Re: Inland Rail – Narromine to Narrabri Project – Environmental Impact Statement Submission

Thank you for the opportunity to make a submission on the Inland Rail (IR) Narromine to Narrabri (N2N) Environmental Impact Statement (EIS). The Narrabri Shire Council Floodplain Risk Management Committee (the Flood Committee) makes the following recommendations;

Figure 1: Alternate Route.

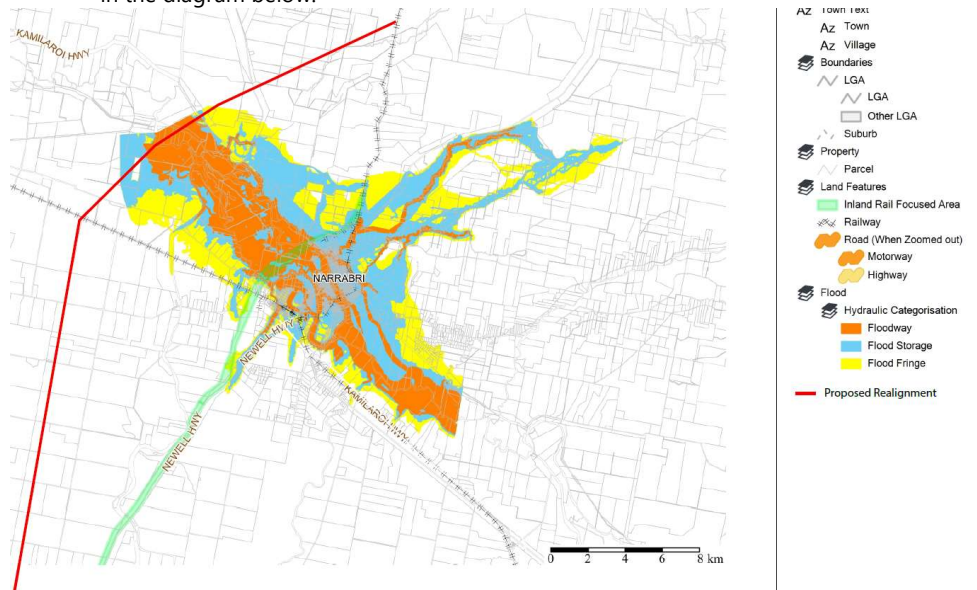
- a) The Flood Committee requests IR investigate the proposed alignment depicted in the diagram below:

- b) The Flood Committee is supportive of IR, however not in the proposed location immediately downstream of the Narrabri Township and crossing the Namoi River Floodplain in the widest location available. It seems counter-intuitive to cross Bohena Creek with a bridge near the Newell, then the Namoi River, the Island Road floodplain (on an angle), Narrabri Creek and the floodplain between Wee Waa Road and Auscott Sheds, with an enormous bridge immediately downstream of the town. By moving the alignment approximately 7 kilometres downstream it is possible to cross Bohena Creek, The Namoi River and Narrabri Creek with one structure half the length of the existing proposed structure across the Namoi and Narrabri Creek.

- IV. The crossing of the Namoi River is now downstream of where the Namoi River, Narrabri Creek and Bohena Creek join, and the bridge length required can be shortened by around 2.0 kilometres compared to the 4 kilometre bridge length required at the current location on the edge of town;

Figure 2: Provisional 1% AEP Afflux of proposed N2N infrastructure.

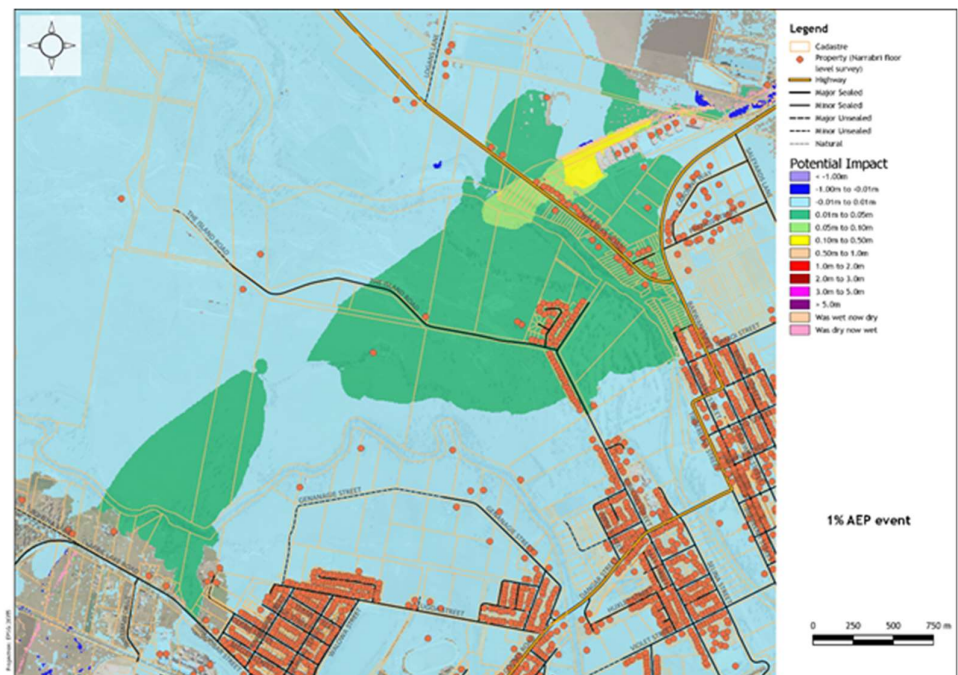
- d) A presentation was given by the IR N2N project team to the Flood Committee on 29 April 2020 outlining the status of the project and their flood investigations so far. The Flood Committee questioned the proposed location of the railway line immediately downstream of the township of Narrabri and highlighted the potential negative flood impacts on the town. Preliminary results showed a 1cm to 10cm increased afflux impact on Wee Waa Road and 1cm to 5cm impact for the Millicent Drive residential area for the 1% Annual Exceedance Probability (AEP) event as evidenced in the Figure below;

- e) IR have maintained that their target for all projects is to limit the afflux on existing buildings to 10mm (1cm). The results show some buildings having an afflux of between 1cm and 5cm.
